Application of Jamila Brown to rezone property from R-75 (Residential Medium Lot-75) and Tier 2 of the I-20 Overlay District to C-1 (Local Commercial) zoning district and Tier 2 of the I-20 Overlay District, at 2570 McAfee Road.

PETITION NO: N2-2026-0708 Z-26-1248023

LOCATION: 2570 McAfee Road, Decatur, Georgia 30032

STAFF ANALYSIS

TASK: **PROPOSED SITE PLAN (ENLARGED WITH DIMENSIONS)**

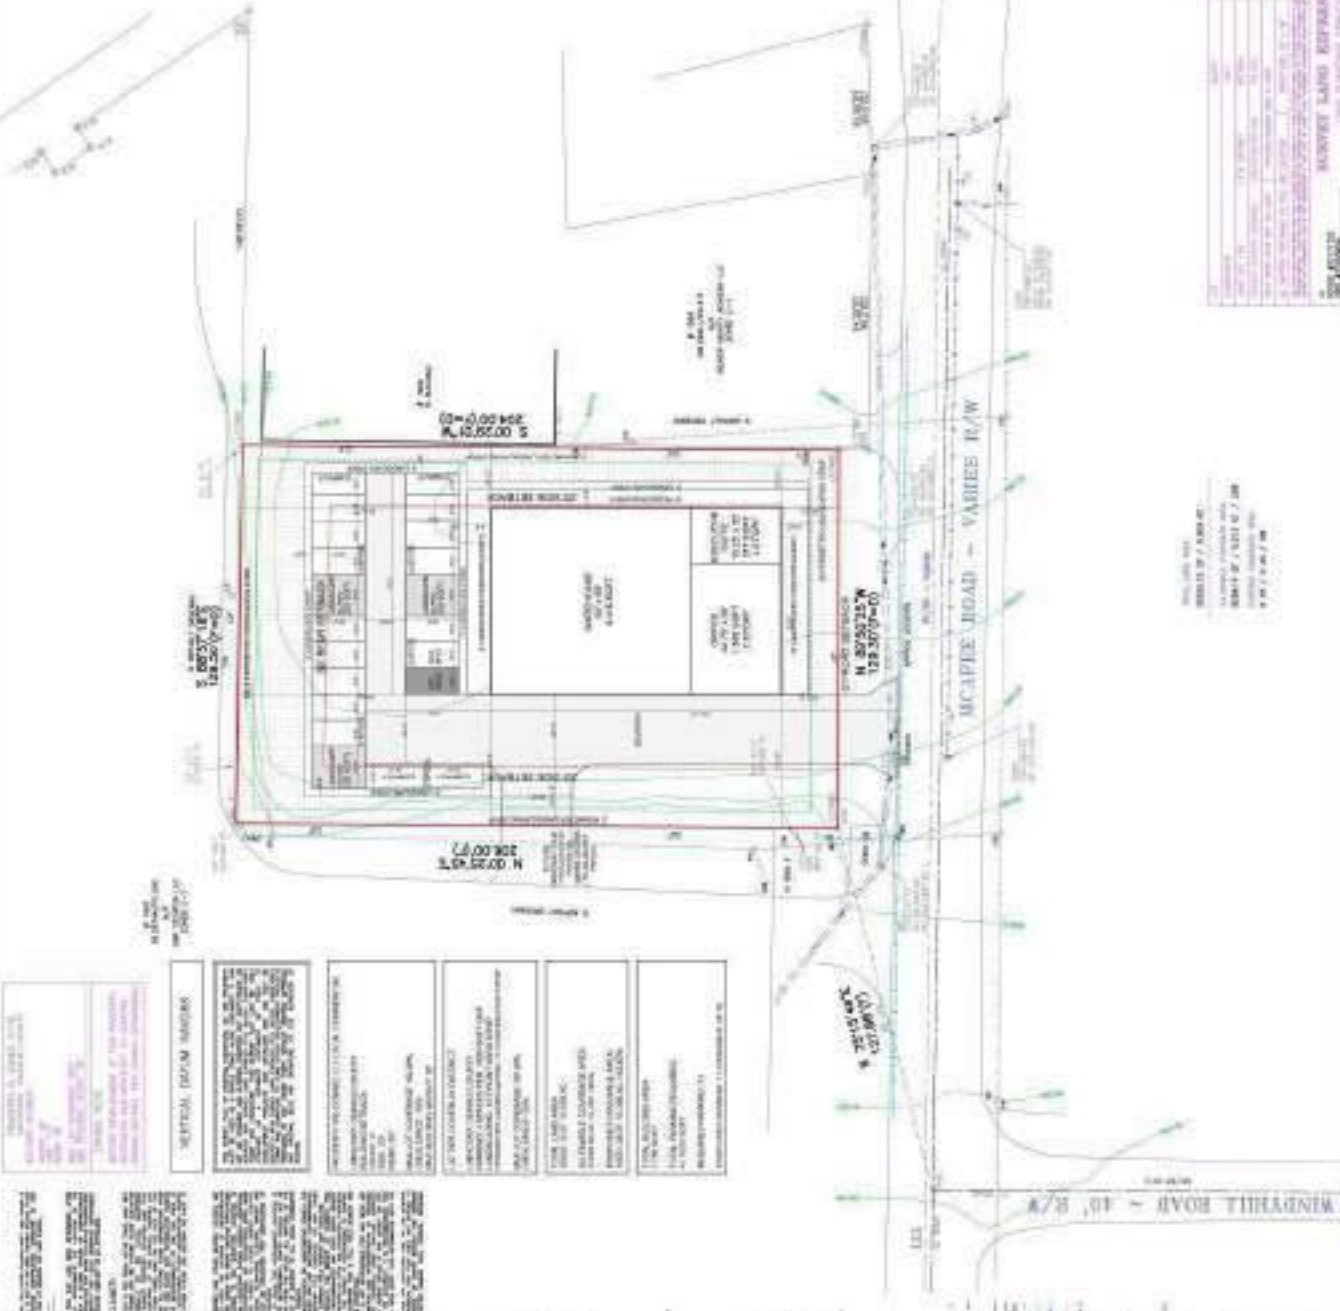
The proposed internal access drive is approximately 14 feet in width-a minimum 24-foot width is required by Chapter 14 (Land Development). This may impact the site's buildable envelope considering the I-20 Overlay development standards, emergency access, two-way circulation, and overall site functionality. The Applicant may reduce and reconfigure landscape islands to accommodate required drive aisle widths and parking standards.

The site plan displays a 10-foot sidewalk with a 5-foot landscape strip along the public street frontage, including street trees, consistent with Section 3.33.14 *A. Sidewalks*. Additionally, the site plan reflects standards of Section 3.33.13 *Landscape strips* requiring 5-foot landscape strips along all side and rear property lines with a 10-foot landscape strip in front of the building. However, Staff notes this configuration can provide better pedestrian circulation by relocating the pedestrian path along the building edge from the northern building line to the southern building line. The southern building line provides a direct connection from the public sidewalk to building entrances, and internal parking areas.

Pursuant to Chapter 27, Zoning Article 3, Overlay District Regulations, Section 3.33.12, Architecture Regulations of the I-20 Corridor Overlay District, and Section 3.33.19, Sign Regulations, the applicant shall demonstrate compliance with all applicable architectural and signage standards prior to the issuance of any permits. Additionally, stormwater management and dumpster location have not been fully detailed on the submitted plan and will require further coordination during final design review to ensure compliance with applicable development regulations. The side setback is potentially 20 feet with the rooftop terrace (otherwise 10 feet). Depending on the redesign and revisions to the site plan and terrace, the 10-foot side setback may provide flexibility to move the building and pedestrian path along the western building line.

The proposed development can be brought into compliance with the intent and requirements of the I-20 Overlay District through revisions required during subsequent plan review and permitting. Outstanding deficiencies remain with respect to Section 3.33.14(A) *Sidewalks*, Section 3.33.13 *Landscape Strips*, and Section 3.33.12 *Architectural Regulations*. Therefore, upon compatibility with the I-20 Overlay and review of Section 7.3.5 *Rezone criteria*, Staff recommends ***“Approval with the following conditions”***:

1. The principal use of the property shall be a general office. Any storage area shall remain accessory and subordinate to principal office use.
2. Warehouse distribution, freight transfer, contractor's yard, and similar storage-oriented commercial uses shall be prohibited.
3. No outdoor storage, outdoor display, outdoor staging of equipment or materials, storage containers, trailers, or commercial vehicles associated with the business shall be permitted on the property, except during active loading and unloading operations.
4. All loading, unloading, and storage activities shall occur entirely within the enclosed building and in the rear of the property.
